REQUEST FOR ADDITIONAL INFORMATION  
**ADAMSTOWN BOULEVARD**  
**PHASE 1**

MCCAULEY DAYE O'CONNELL ARCHITECTS

QUINTAIN

Planning Ref: SDZ22A/0007  
Application Date: 06-05-2022

Figure 6-1 Location of recommended block wall (noise barrier) to rear gardens near the railway line

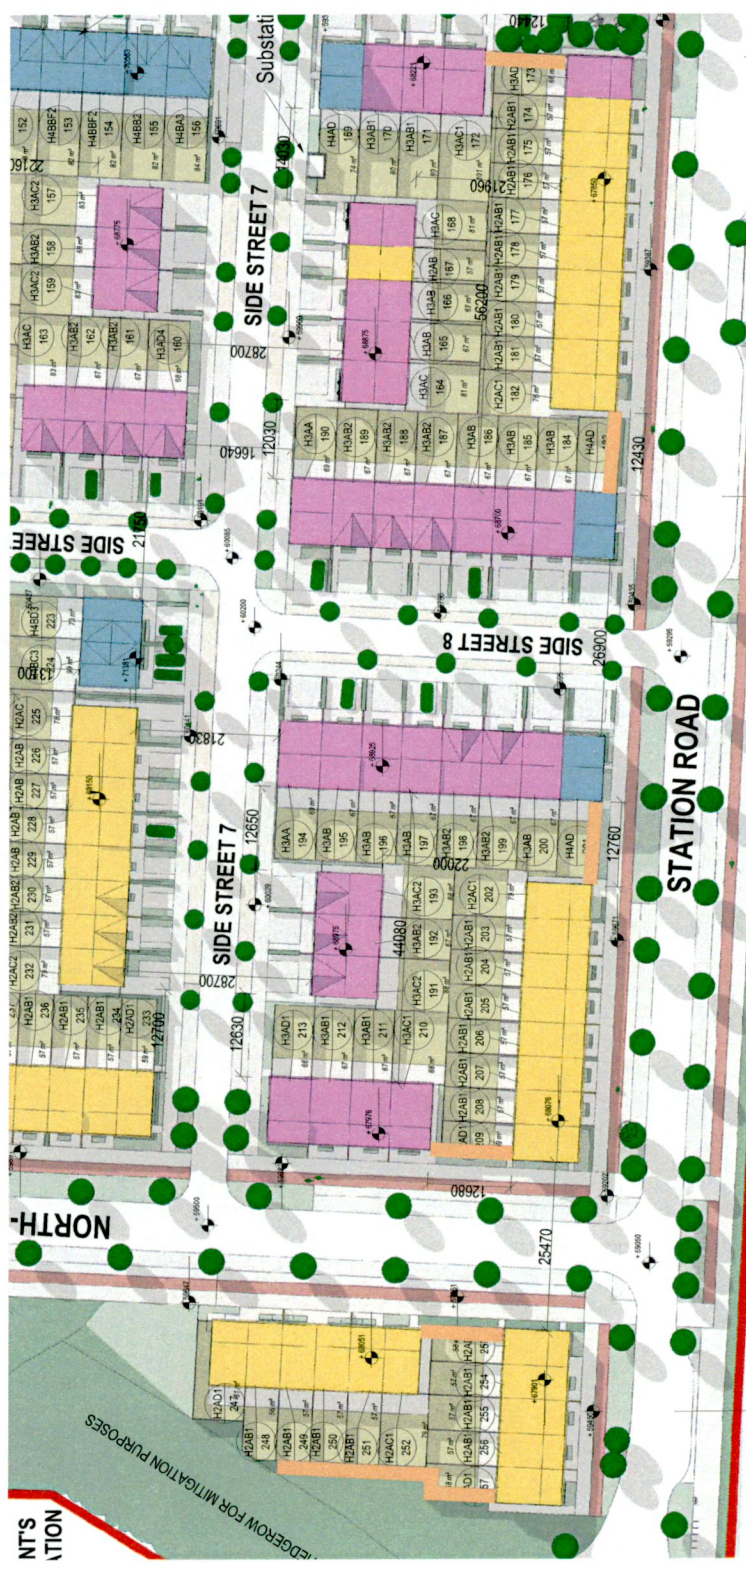
AN ACOUSTIC ASSESSMENT MUST BE UNDERTAKEN BY A SUITABLY QUALIFIED  
ACOUSTIC CONSULTANT DESCRIBING AND ASSESSING THE POTENTIAL NOISE IMPACT OF  
THE NEARBY RAILWAY LINE ON THE PROPOSED DEVELOPMENT

- To reduce noise exposure in private gardens, a 2.4m solid brick wall has been recommended, in specific locations
  - Enhanced glazing build up has been recommended for dwellings facing the railway line (Station Rd).
- The proposed windows will achieve the recommended value of min 41dB.

# 2.1 RFI 3.A H3AA - AS SUBMITTED

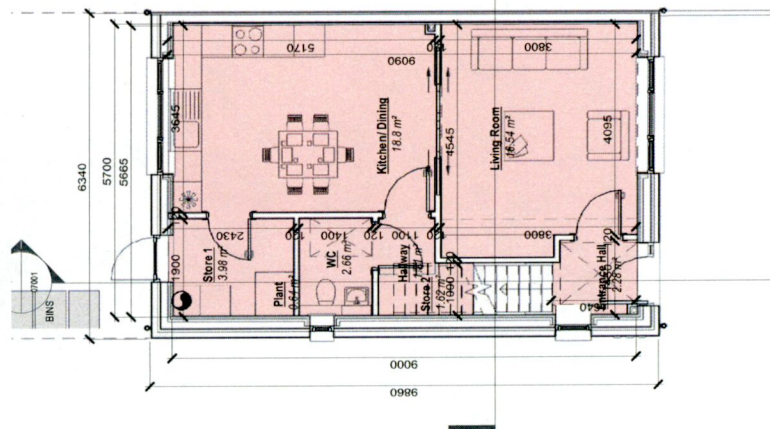
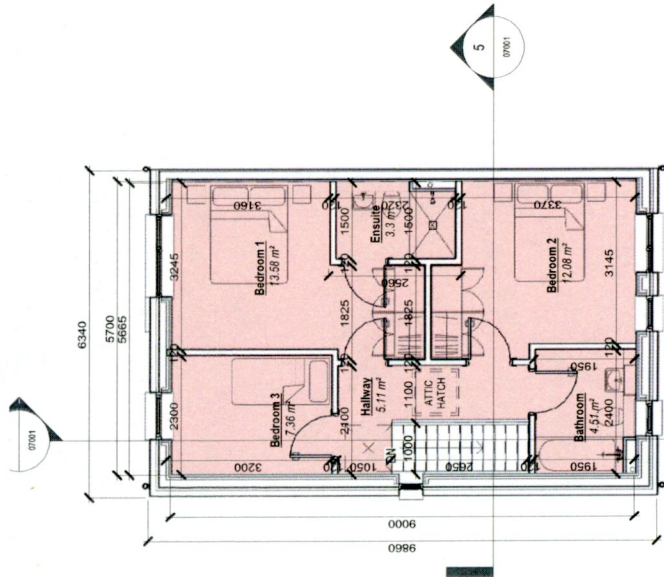
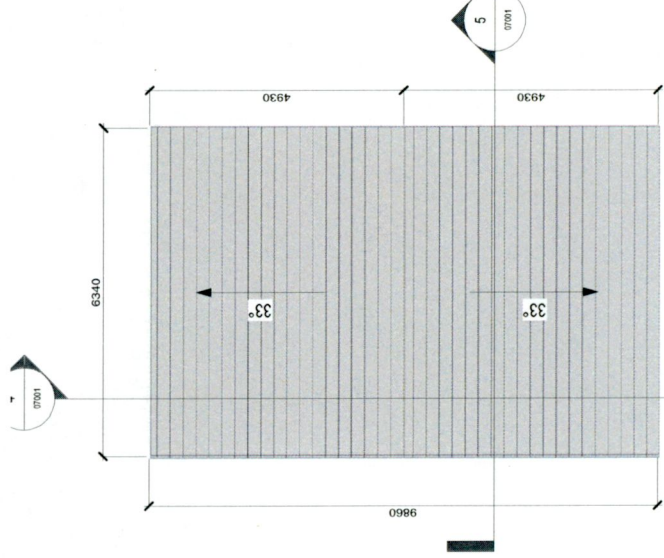
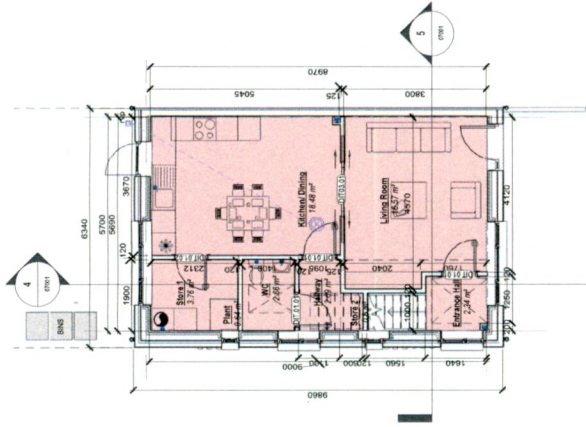
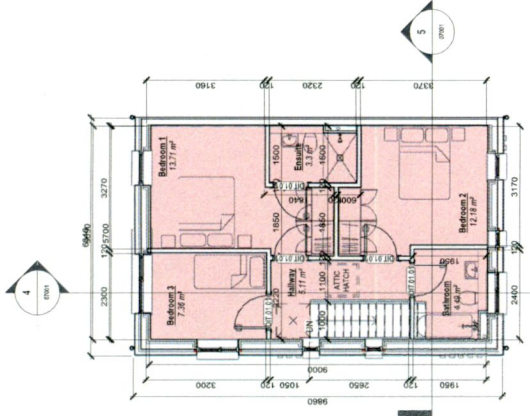
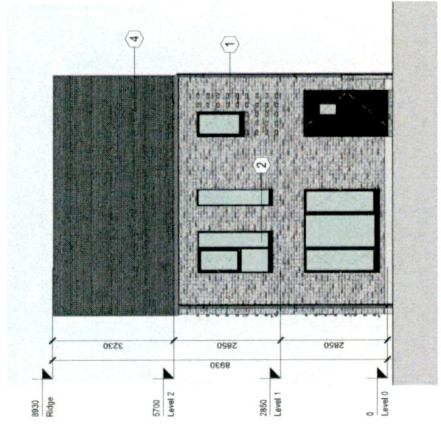
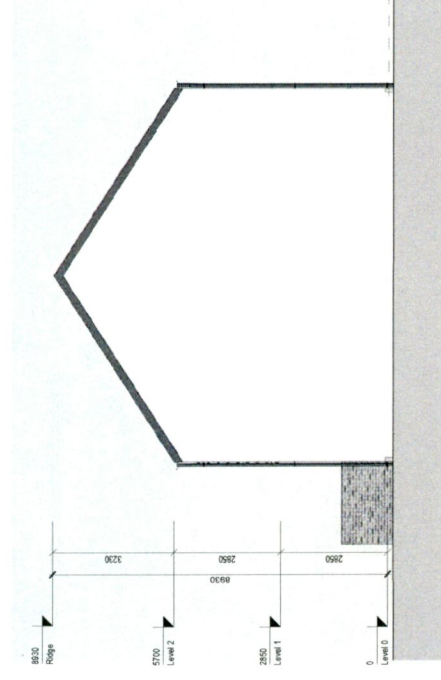
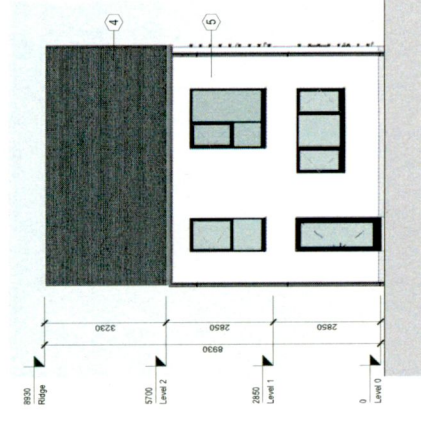
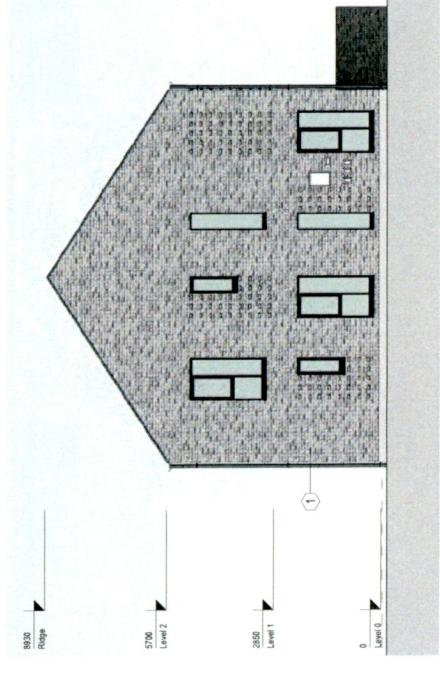
The applicant was requested to increase openings to provide passive surveillance on House Type H3AA.

To increase passive surveillance, the proposal is to mirror the floor plan on Level 0 and Level 1. This will increase the extent of windows on the side elevation.

# 2.2 RFI 3.A H3DA - AS SUBMITTED

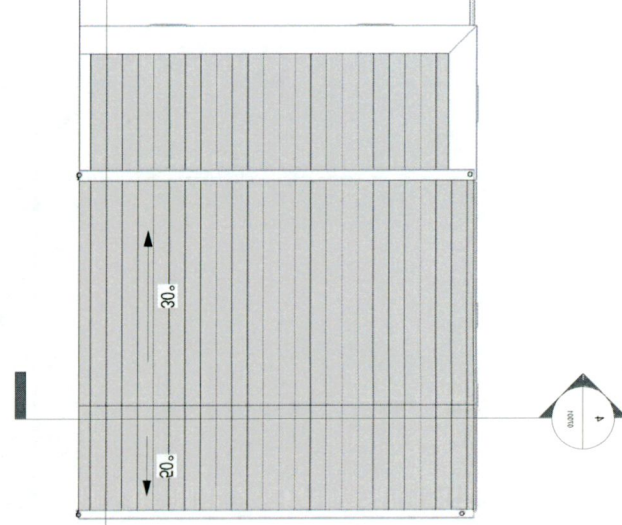
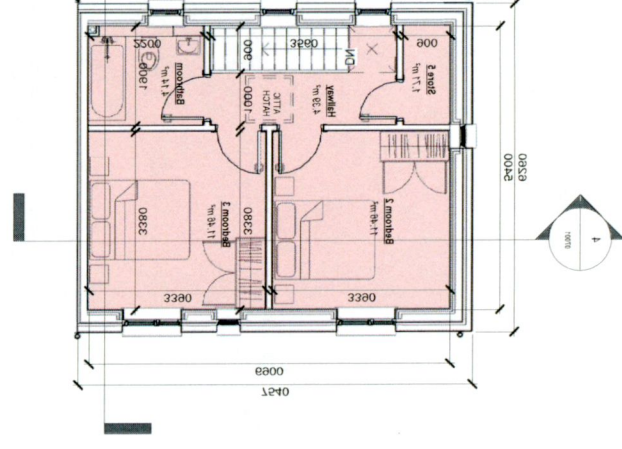
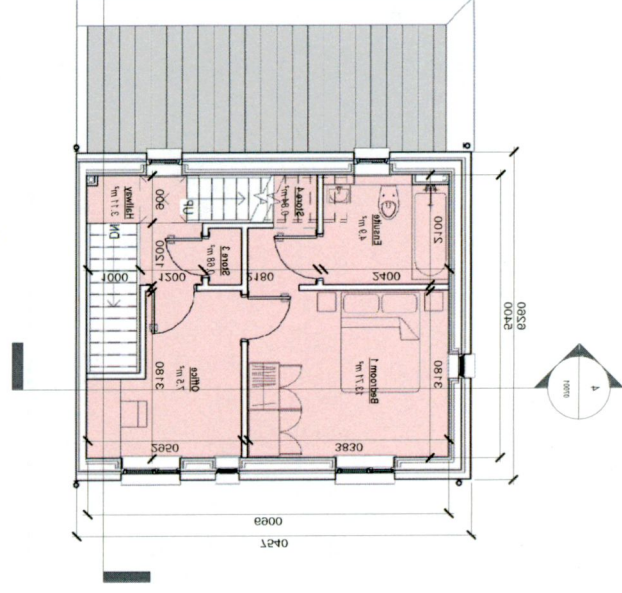
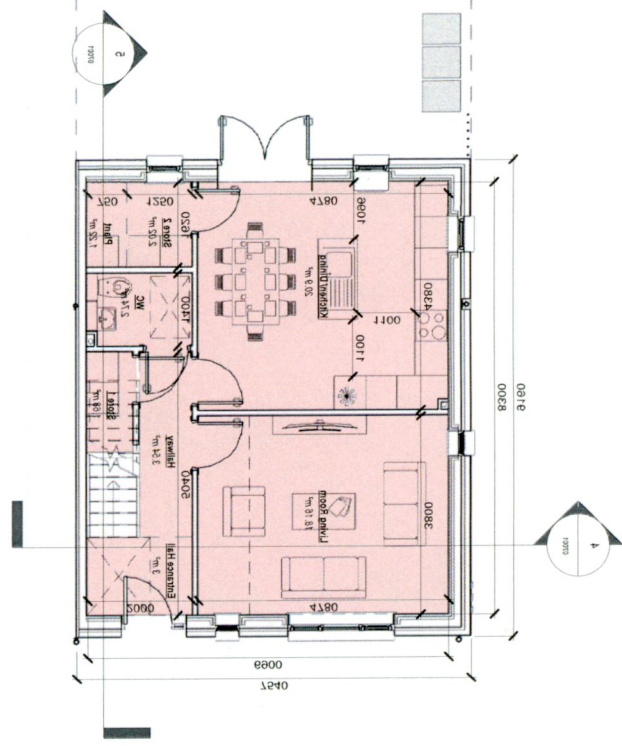
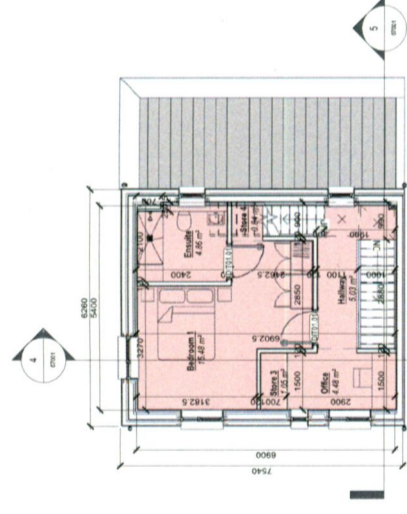
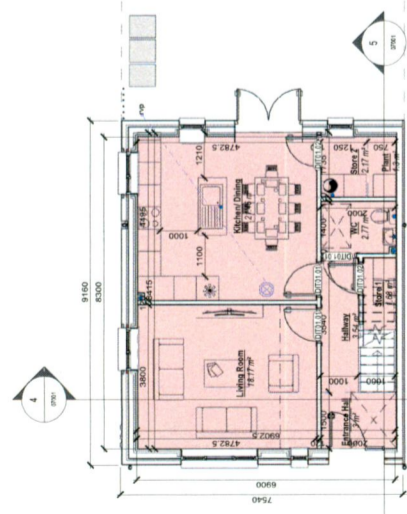
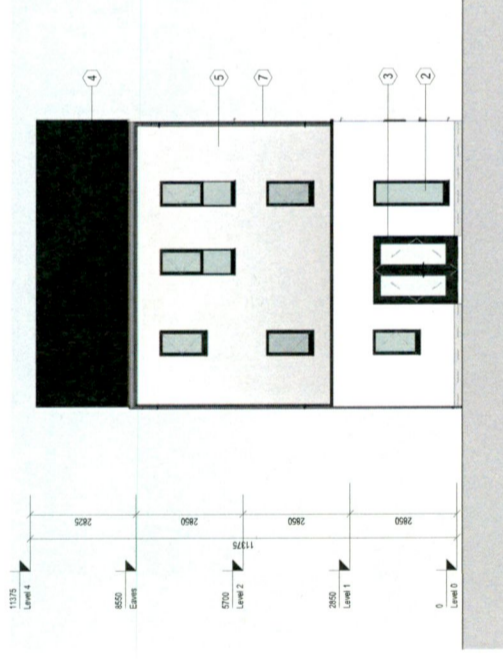
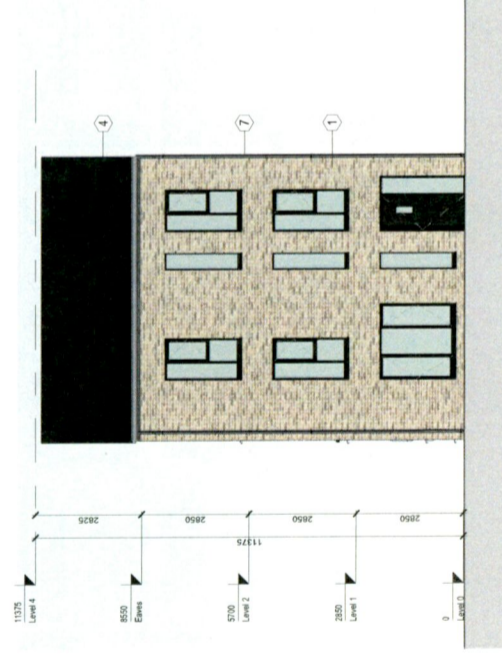
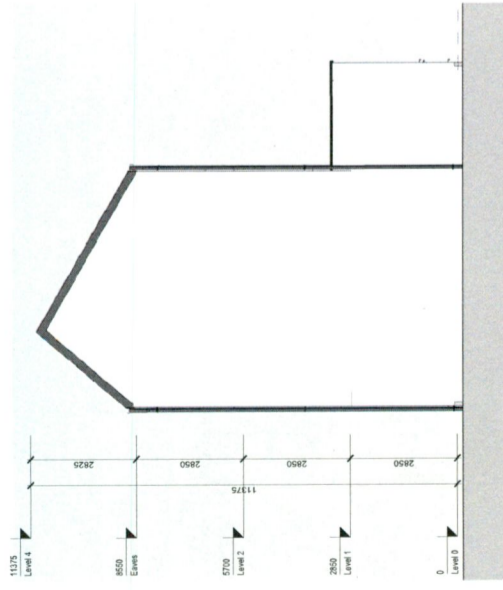
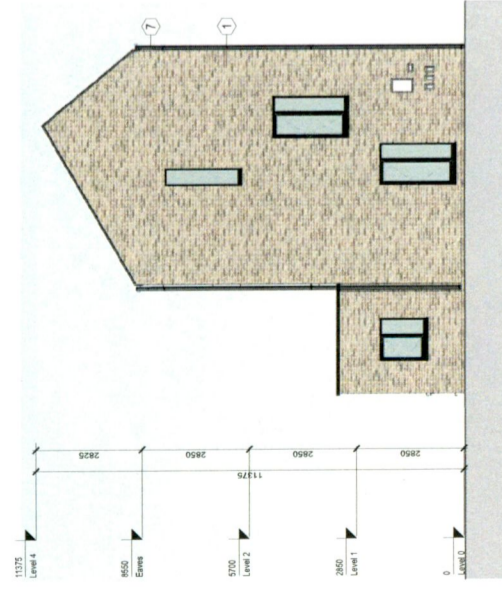
The applicant was requested to increase openings to provide passive surveillance on House Type H3DA. The drawings to the left show the plans and elevations of what was submitted. Also shown are indicative CGIs.

To improve passive surveillance, we propose to increase the extent of windows on the side elevation, therefore increasing passive surveillance onto the street.

## H3DA - AS SUBMITTED

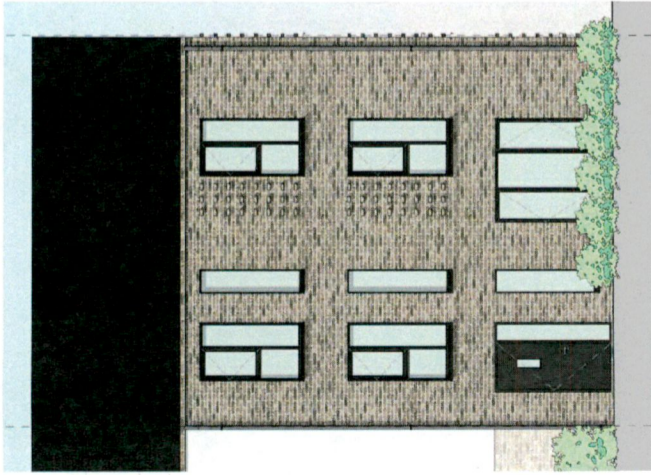
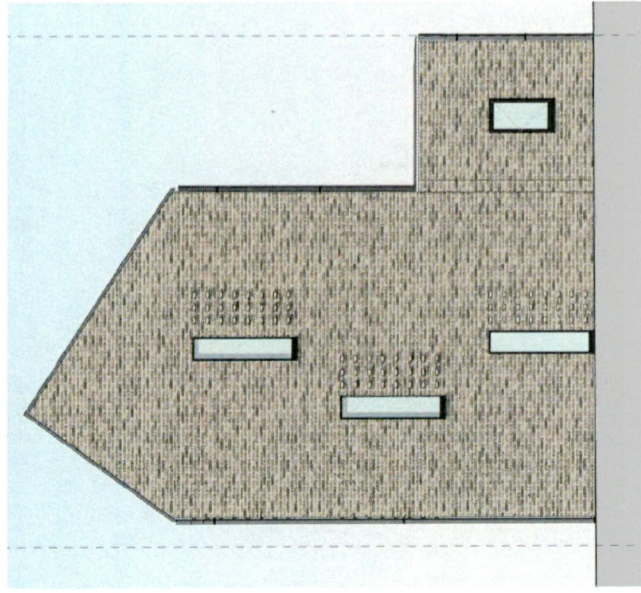
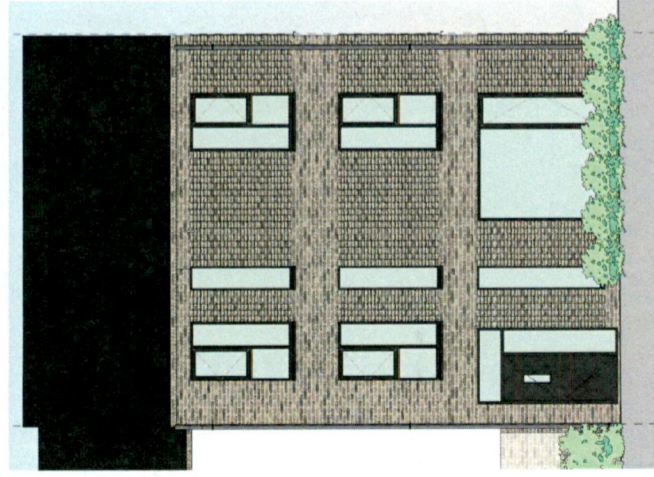
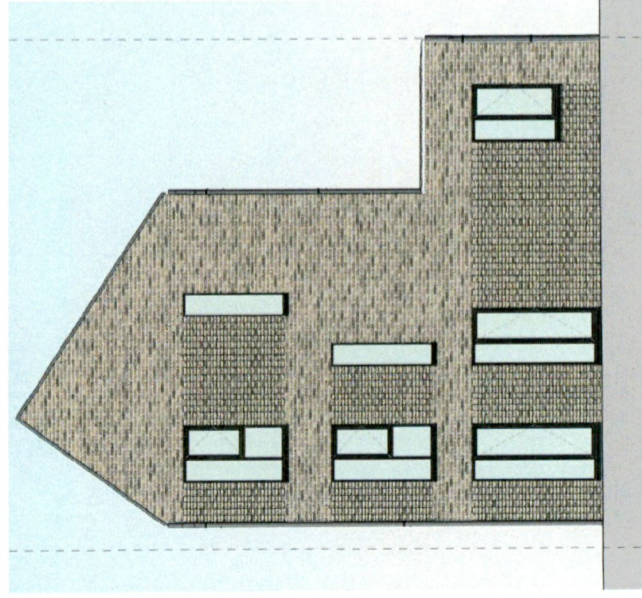
SDCC have requested further details of each landmark to demonstrate their significant design quality and discernibility from adjacent buildings.

- In order to further emphasise the landmark features, we have;
- increased brick detailing extent to exposed gables
  - increased the height of the building by increasing the ground floor to ceiling height including windows and door.
  - maintained alternative brick colour to clearly differentiate from the adjacent buildings.
  - increased window extent as a consequence of the passive surveillance RFI query

## H4HA - AS SUBMITTED

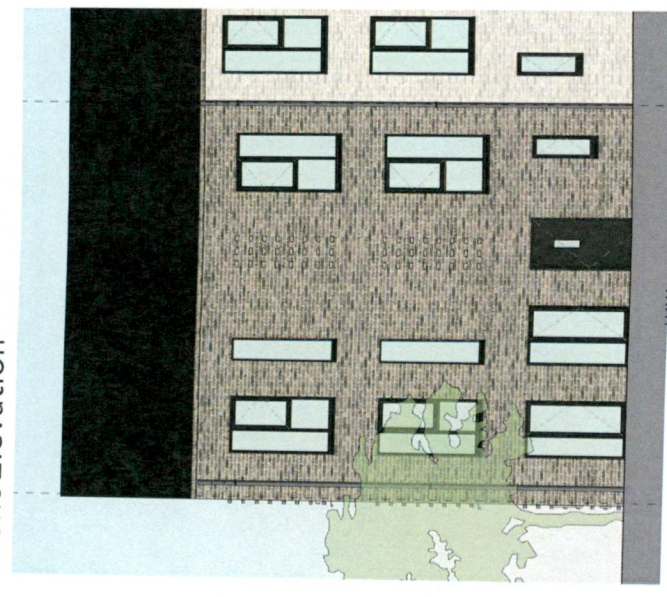
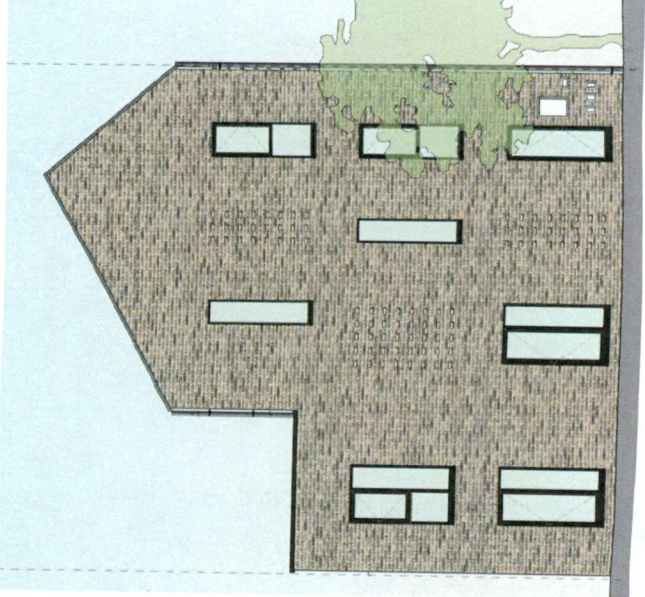
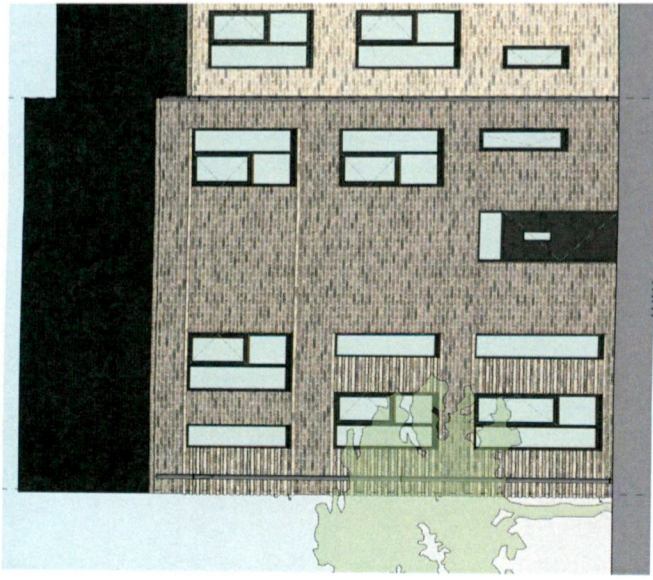
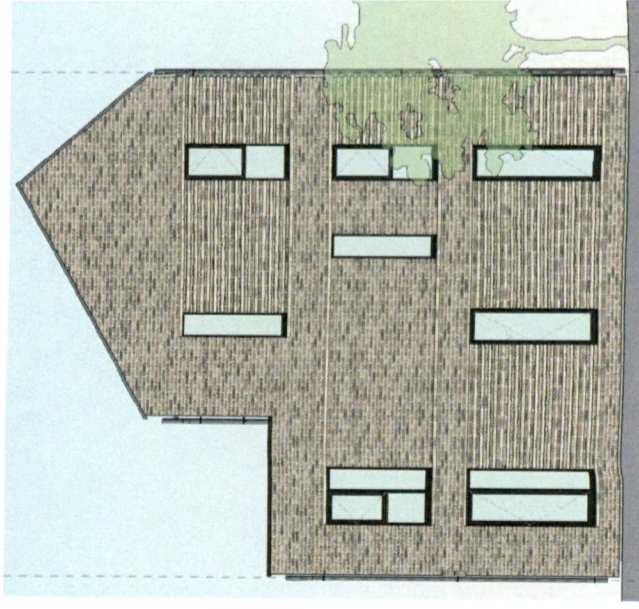
SDCC have requested further details of each landmark to demonstrate their significant design quality and discernibility from adjacent buildings.

- In order to further emphasise the landmark features, we have;
- alternative brick detailing extent to exposed gables that turn the corner
  - increased the height of the building by increasing the ground floor to ceiling height including windows and door.
  - maintained alternative brick colour to clearly differentiate from the adjacent buildings.
